Technical Service Bulletin

SUBJECT:		No: TSB-24-33-002	
FRONT COIL SPRING AND STRUT DESCRIPTION CORRECTION - SERVICE MANUAL REVISION		DATE: August 2024	
		MODEL: Outlander	
CIRCULATE TO:	<input type="checkbox"/> GENERAL MANAGER	<input checked="" type="checkbox"/> PARTS MANAGER	<input checked="" type="checkbox"/> TECHNICIAN
<input checked="" type="checkbox"/> SERVICE ADVISOR	<input checked="" type="checkbox"/> SERVICE MANAGER	<input checked="" type="checkbox"/> WARRANTY PROCESSOR	<input type="checkbox"/> SALES MANAGER

This TSB provides corrections to the Front Coil Spring and Strut description in the Suspension section of the applicable Service Manuals.

DF100AH1AB00ENG

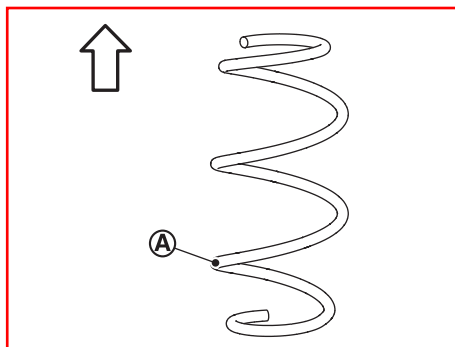
- Set coil spring so that its paint marks are aligned with the position from the bottom end of the coil spring as shown in the figure.

<Corrected>

<Deleted>

<Deleted>

- Be sure a spring compressor is securely attached to coil spring, before compress coil spring.
- Align the lower end of coil spring (1) with lower rubber seat (2) as shown in the figure.

Dimension (A) : 5 mm (0.20 in) or less
